WILLIAMSON COUNTY, TEXAS

CHANGE ORDER NUMBER: 3

Project: 221FB39

Roadway: CR 111

ESTIMATE & QUANTITIES

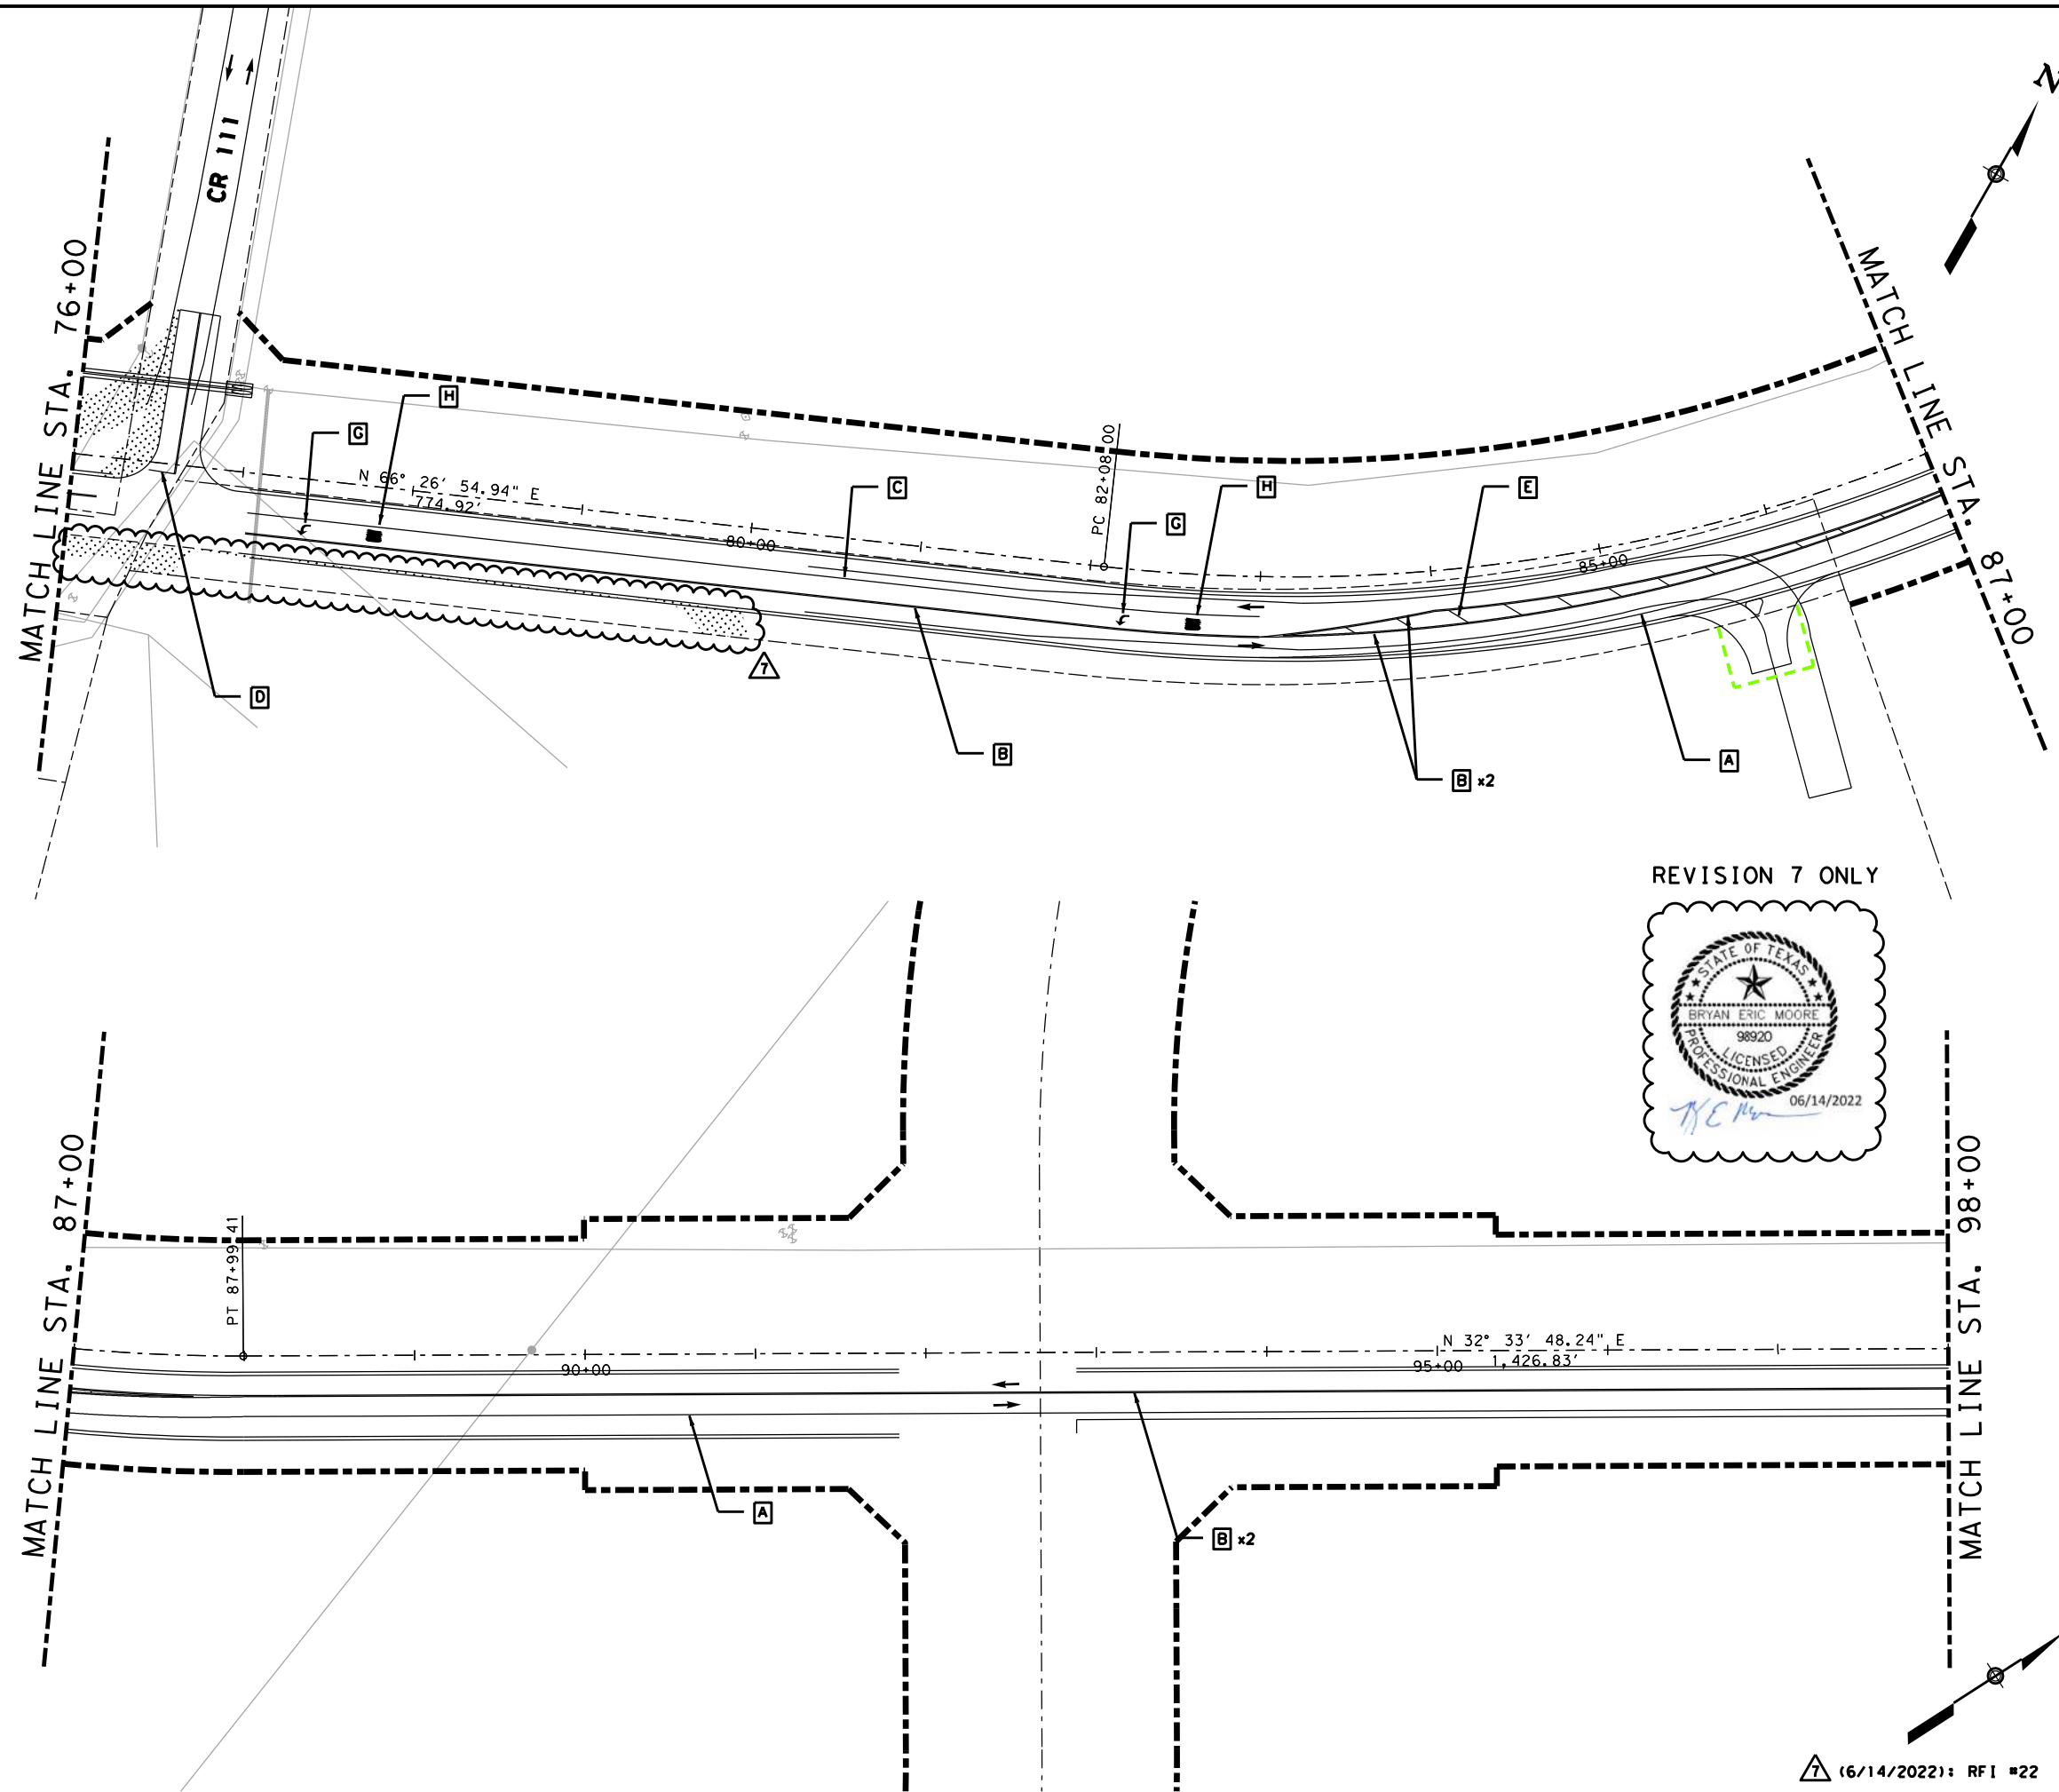
1. Design Error or Omission. 1A: incorrect PS&E. This Change Order is in response to RFI 22 that updated the quantity for pay item 106-6002 OBLITERATING ABANDONED ROADWAY. The item has been recalculated and the difference is included in this Change Order to cover the actual quantity.

This Change Order revises the original plan quantity for the "Obliterating Abandoned Roadway" item. The quantity in the plans has been updated to reflect the existing conditions. The Engineer has revised the item quantity and plan sheets to include the updated quantity and locations of the obliteration areas.

The existing roadway is called out to be obliterated from 1460 on as shown in the phase III TCP's, however the quantity summary only includes partial removal areas beginning at STA 87+00 to 98+00. Please review the plan quantity for item 106+6002 Obliterating Abandoned Roadway, and adjust to include all of the roadway obliteration called out in the plans.

Additionally, no removals are called out for the existing roadway in front of the Gateway school that must be removed to construct the proposed roadway. Please review and provide an avenue for payment for the existing roadway removal.

Quantities have been updated to account for all removal areas including existing road for Gateway. The removal of existing road outside of the proposed roadway in the plans is quantified by the item 106-6002 Obliterating Abandoned Road and the portion underneath the proposed roadway is covered by item 110-6001 Excavation (Roadway). The removal quantities for CR 110 are included in the CR 110 portion of the plans.

7 (06/14/22): RFI #22
